Accessibility Survey

City of Downey Danvers Street - Lowman Avenue to End

Date of Inspection
2/5/2017

Prepared By
Disability Access Consultants
(800) 743-7067

Sidewalk East Of Lowman Avenue @ 33.964057847969, -118.121404498816

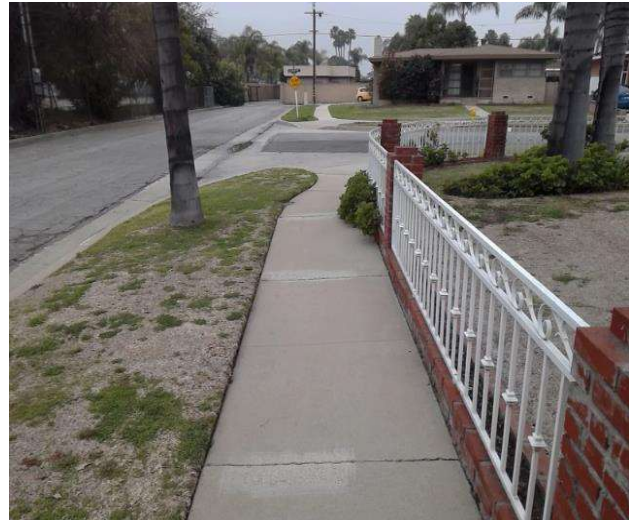
Sidewalk cross slope is not compliant.

On-Site Finding 3.50 percent for 35.00 feet

Repave the sidewalk surface with the recommended cross slope.

Recommendation Up to 2.08 percent

Change In Level West Of Smallwood Avenue @ 33.967419140813, - 118.124603033066

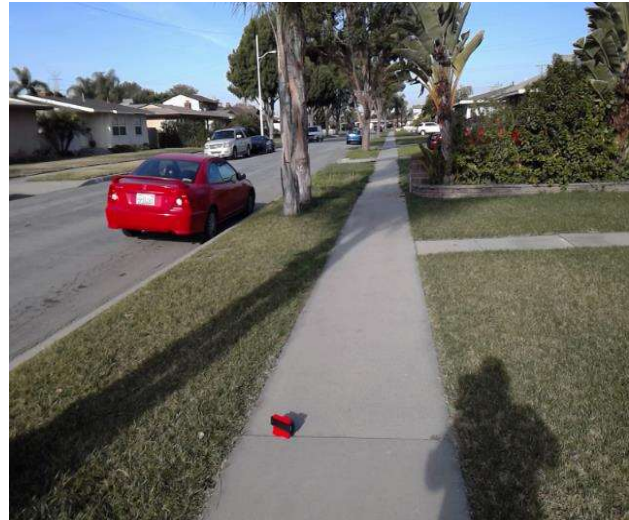
There is a change in elevation greater than recommended value.

On-Site Finding 0.50 inches

Ensure that the change in elevation is within the recommended value.

Recommendation Up to 0.25 inches

Change In Level East Of Guatemala Avenue @ 33.967176669468, - 118.124412596226

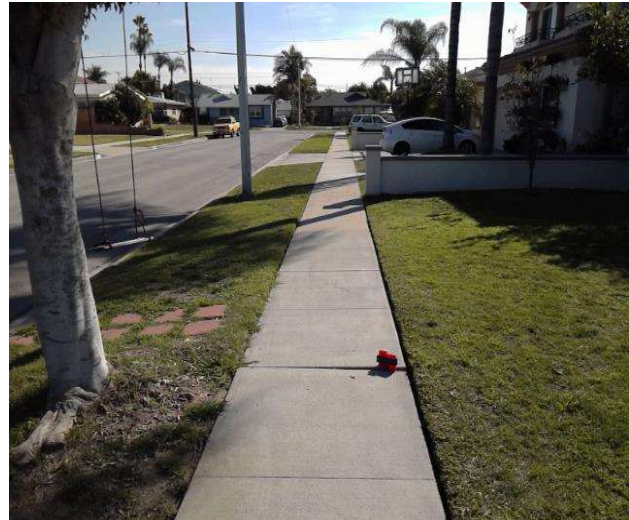
There is a change in elevation greater than recommended value.

On-Site Finding 0.75 inches

Ensure that the change in elevation is within the recommended value.

Change In Level East Of Guatemala Avenue @ 33.967997510038, - 118.126051425934

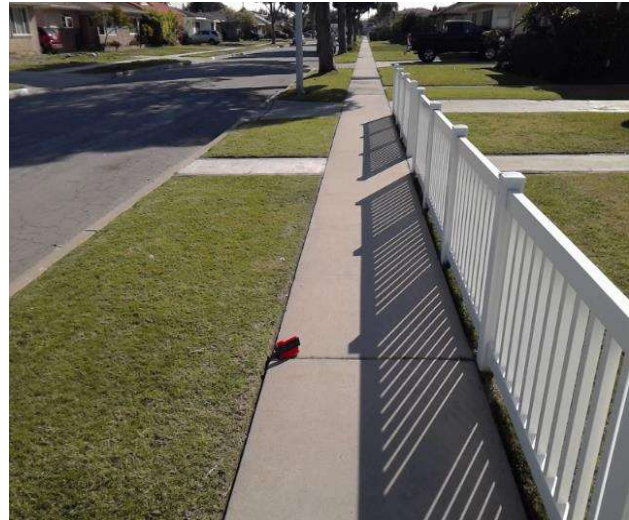
There is a change in elevation greater than recommended value.

On-Site Finding 0.50 inches

Ensure that the change in elevation is within the recommended value.

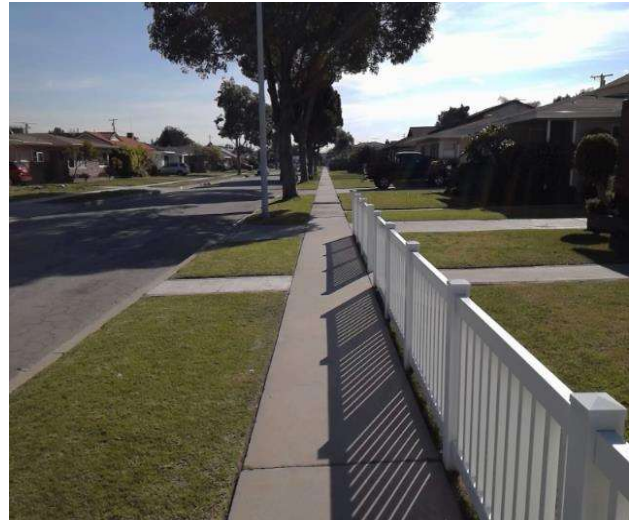
Sidewalk cross slope is not compliant.

On-Site Finding 3.30 percent for 165.00 feet

Repave the sidewalk surface with the recommended cross slope.

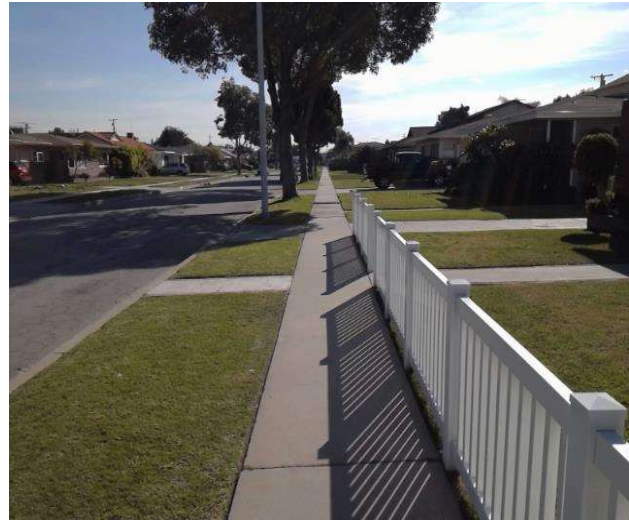
Sidewalk running slope is not compliant.

On-Site Finding 10.10 percent for 2.00 feet

Repave the sidewalk surface with the recommended running slope.
